MIL ON With Companion Cylinder Misfire DTCs

Service Category Engine/Hybrid System

YEAR(S)	MODEL(S)	ADDITIONAL INFORMATION
2018 - 2021	RX350

REVISION NOTICE

Figure 2. Location of Authorized Modifications Label on 2018 – 2021 RX 350

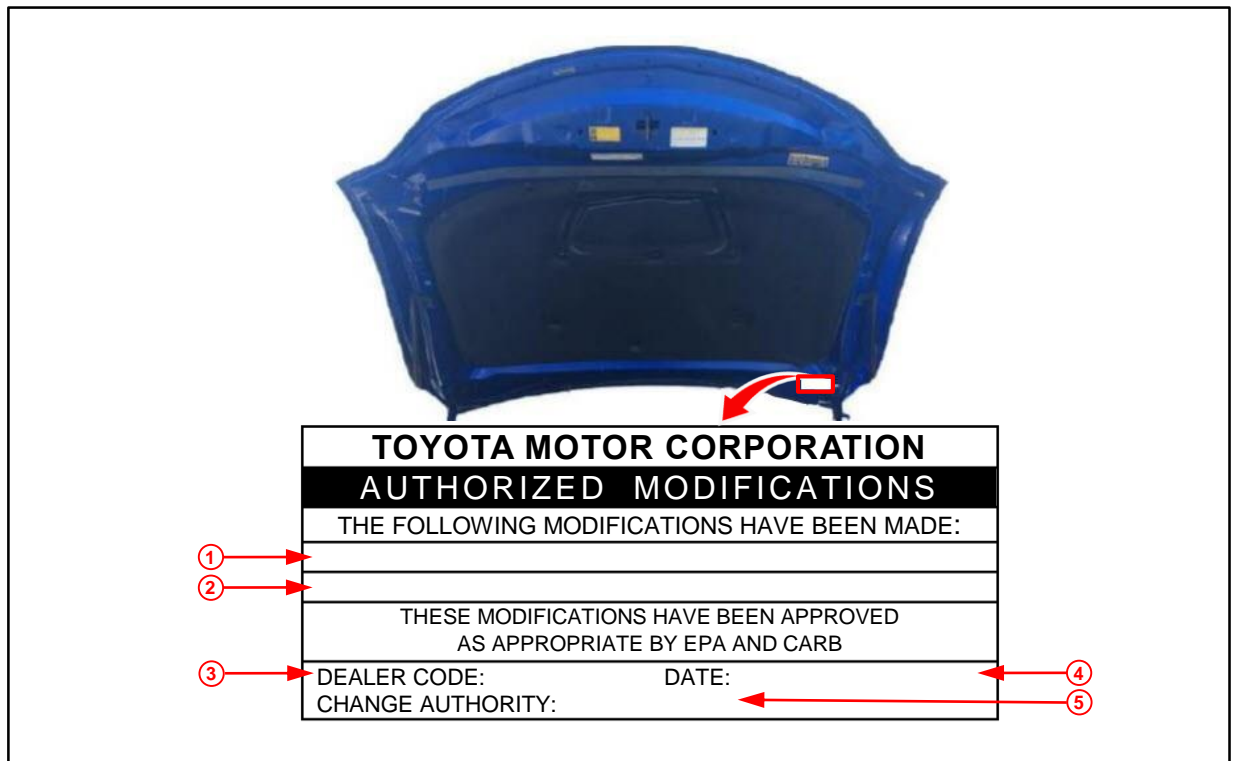
1. Use Techstream to confirm if the ECM (PCM) calibration has been updated and check for the Authorized Modifications Label affixed to the vehicle in the location shown below.

Is the calibration ID listed in Techstream and on the label the latest ECM (PCM) calibration?

3. Prepare and install the Authorized Modifications Label.
 - A. Using a permanent marker, enter the following information on the label:
 - ECM (PCM) part number [*Refer to the **Parts Information** section for the **NEW PART NUMBER**.*]
 - Calibration ID(s) [*Refer to the **Calibration Information** section for the **NEW CALIBRATION ID**.*]
 - Dealer Code.
 - Repair Date.
 - Change Authority [***This bulletin number***].
 - B. Install the Authorized Modifications Label onto the vehicle at the location shown in Figure 1. The Authorized Modifications Label is available through the MDC, P/N 00451-00001-LBL.
4. Test-drive the vehicle to confirm the condition no longer exists.
